STOCKING PELHAM –  
ENERGY  
DEVELOPMENT SITES

Acoustic Appraisal

Reference: 12622.RP01.ENS.1  
Prepared: 27 November 2023  
Revision Number: 1

Graph 2 – Comparison of source noise levels near existing substations and worst-case resulting background levels at RBA survey receptors

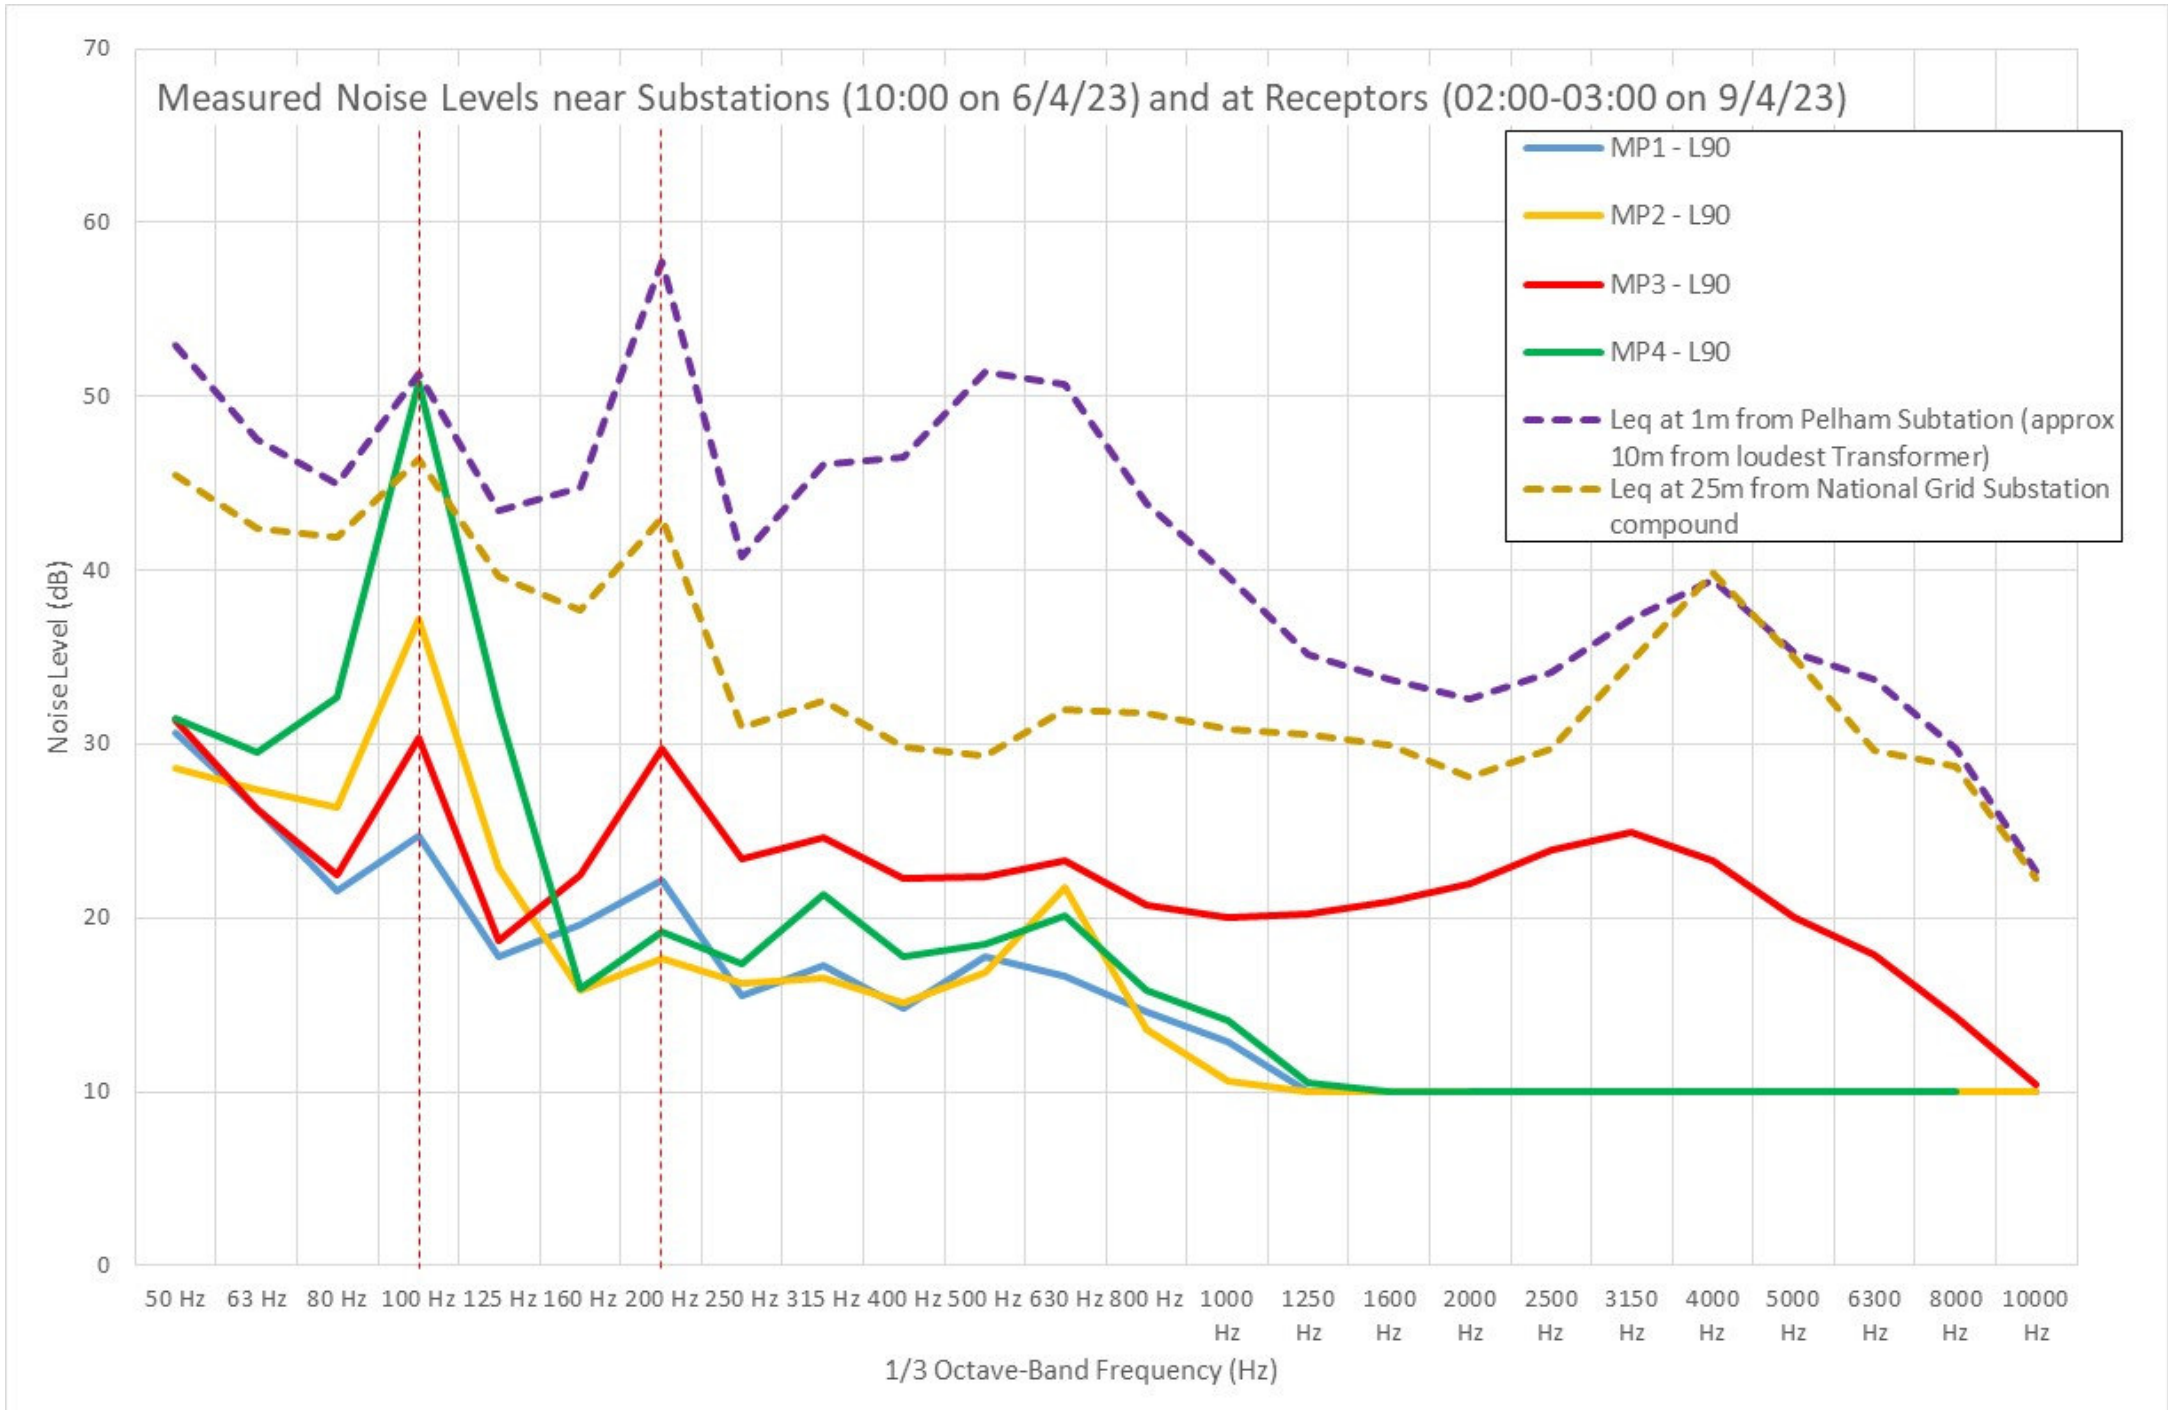
From analysis of Graph 2 we can make the following observations:

- Both of the source noise levels near to National Grid and Pelham Substations contain notable peaks / tones at 100Hz and 200Hz. The 200Hz peak close to the Pelham substation has a level difference of 13dB and 17dB to adjacent 1/3 octave-band levels, which indicates a strong degree of tonality at the source. Of course, the presence of tonality at source does not necessarily result in audible tonality at the receptor.

- In the worst-case resulting noise levels at receptors MP1-MP4, peaks /tones are notable at 100Hz and 200Hz, however the degree of prominence of each peak varies at different receptors. The most notable is a significant peak at 100Hz for MP4 which has a level-differences of 18dB and 19dB to adjacent 1/3 octave-band levels. Receptors MP2 and MP4 have more prominent peaks at 100Hz but smaller peaks at 200Hz, whereas receptors MP1 and MP3 have 100Hz and 200Hz peaks which are more proportionate to one another, which may indicate the same noise source. Given the accounts of the local residents stating that substation noise is often audible (and claiming that this is due to the Pelham Substation), this appears to tie in with the measured data, where the presence of peaks at these key frequencies is a strong indication of audibility and therefore the need to include some form of tonality correction in prediction assessments, to account for such worst-case scenarios.

- Above around 1250Hz, noise levels were below the noise floor of meters MP1, MP2 and MP4, which is shown as the lines plateauing at 10dB. For meter MP3, the presence of consistently louder high frequency is understood to be caused by a nearby garden water fountain which was audible at the measurement location.

Appendix B within Pelham Substation Acoustic Report showing noise level predictions

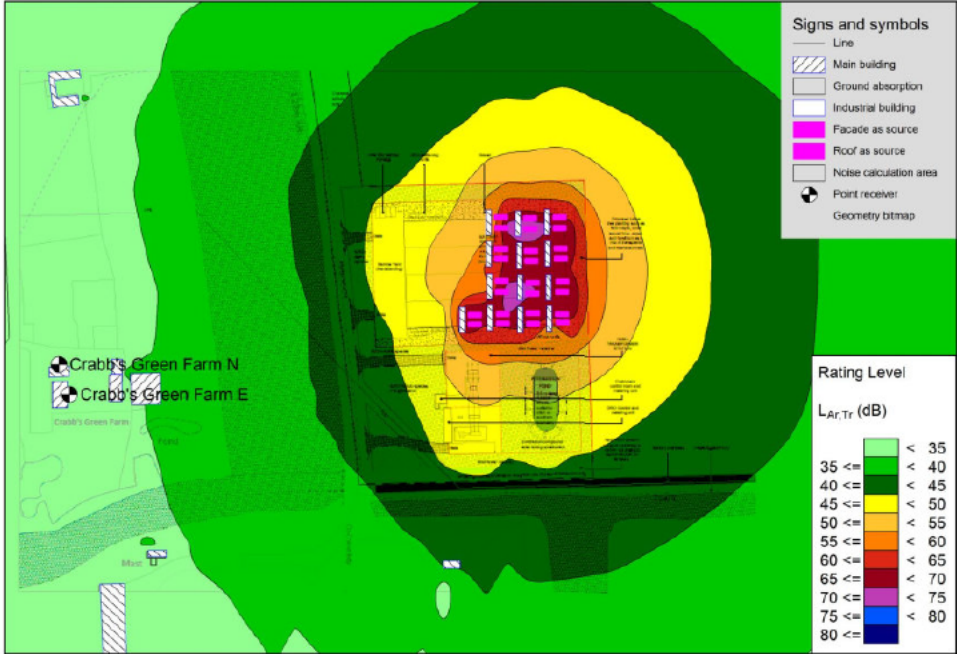
- Section 7.4 confirms that the assessment does indicate rating levels which exceed the background levels for each respective assessment period (by up to 8dB in the worst-case night-time period) and confirms that this is an indication of adverse impact. However, the report continues, to argue that the absolute noise levels are suitable when assessed as single-figure noise levels, against the single-figure criteria given in the World Health Organisation’s document ‘WHO Guidelines For Community Noise’. Although numerically the numbers are correct, this could potentially be underestimating the significance of the potentially disturbing character of the resulting plant noise, given that such analysis is frequency independent.

Figure 2 within Crabbs Lane Acoustic Report showing proposed plant items

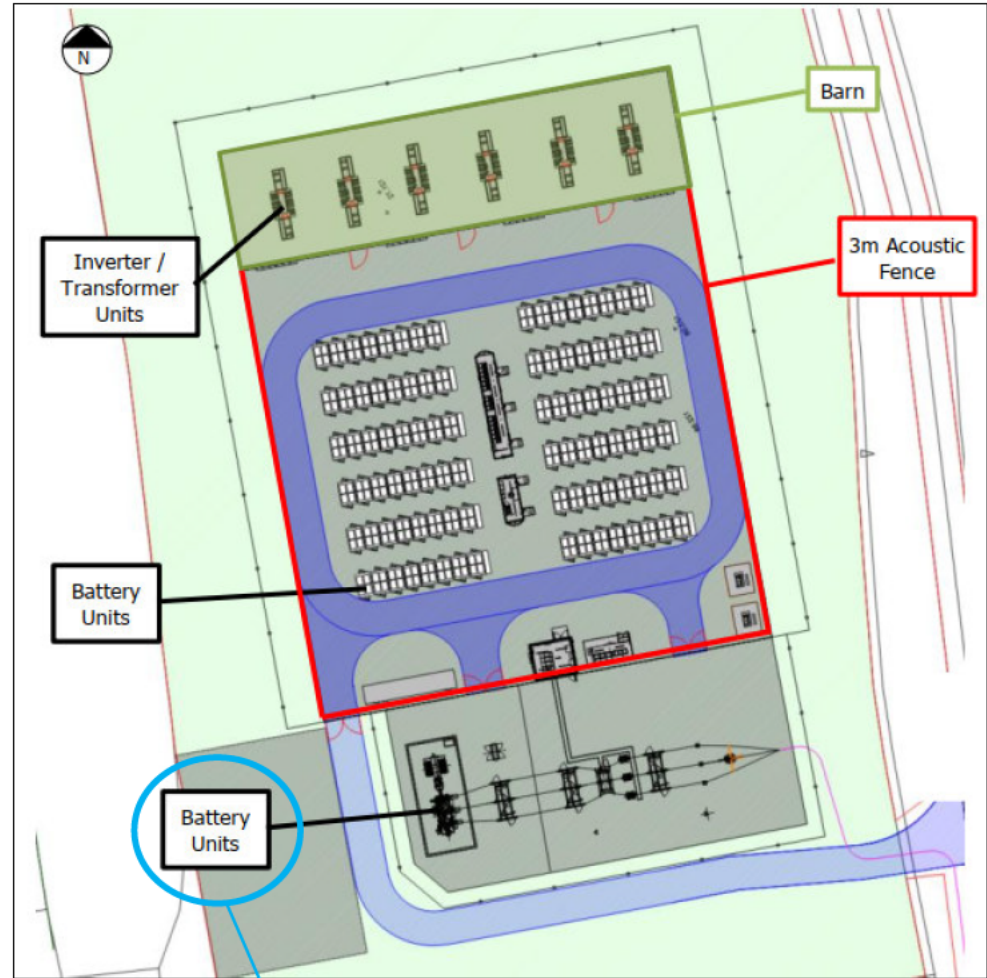
We believe this is a typo and should be labelled as 'Distribution Network Operator (DNO)'
